Access Compliance Report

Public Rights-of-Way

(Curb Ramps)

Intersection ID: 14846	Main Street: HENLEY_PL	Cross Street: S_KINGS_DR	Location: W
ADA ID: E946AAF47094	Ramp Type: PerpDiag	Initial Pass/Fail: Fail	Overall Compliance: No
			Severity Score: 13.75

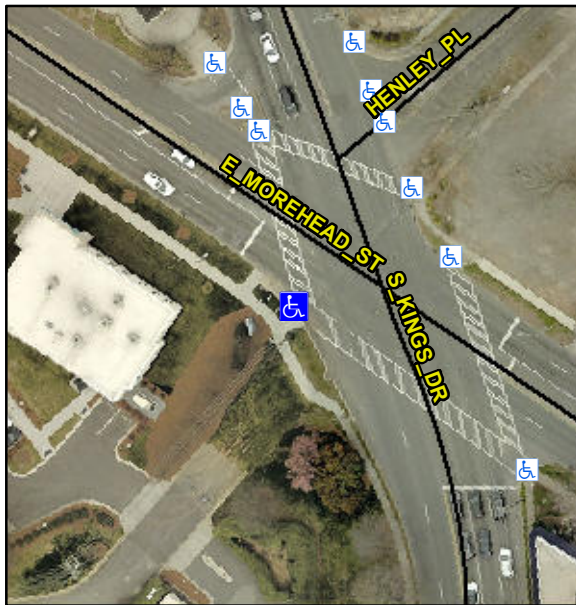
Not Found, R304.2.2

Compliance	Description	Data	Compliance	Description	Data
N/A	Ramp Length (in)	68.0	No	Ramp Slope (%)	9.5
Yes	Ramp Width (in)	48.0	Yes	Ramp XSlope (%)	3.9
N/A	Flare Type LT	N/A	N/A	Flare Type RT	N/A
N/A	Flare Slope LT (%)	N/A	N/A	Flare Slope RT (%)	N/A
N/A	Flare Traversable LT?	N/A	N/A	Flare Traversable RT?	N/A
N/A	Landing Length (in)	N/A	N/A	DWS Provided?	N/A
N/A	Landing Width (in)	N/A	N/A	DWS Contrast?	N/A
N/A	Landing Slope (%)	N/A	N/A	DWS Length (in)	N/A
N/A	Landing X Slope (%)	N/A	N/A	DWS Full Width?	N/A
N/A	Landing Curb? (Y/N)	N/A	N/A	DWS Offset (in)	N/A
N/A	Shared Landing?	N/A			
N/A	Gutter Ponding?	N/A	N/A	Gutter Slope (%)	N/A
N/A	Gutter Lip Ht (in)	N/A	N/A	Gutter X Slope (%)	N/A
N/A	Painted X Walk1?	Yes	N/A	Painted X Walk2?	Yes
	X Walk 1 Direction	To SE		X Walk 2 Direction	To N
N/A	X Walk 1 Width (in)	112.0	N/A	X Walk 2 Width (in)	99.0
	X Walk 1 Slope (%)	7.7		X Walk 2 Slope (%)	1.8
	X Walk 1 X Slope (%)	2.2		X Walk 2 X Slope (%)	8.9

Remove & Replace Curb Ramp With Two New Directional Ramps or Equivalent.
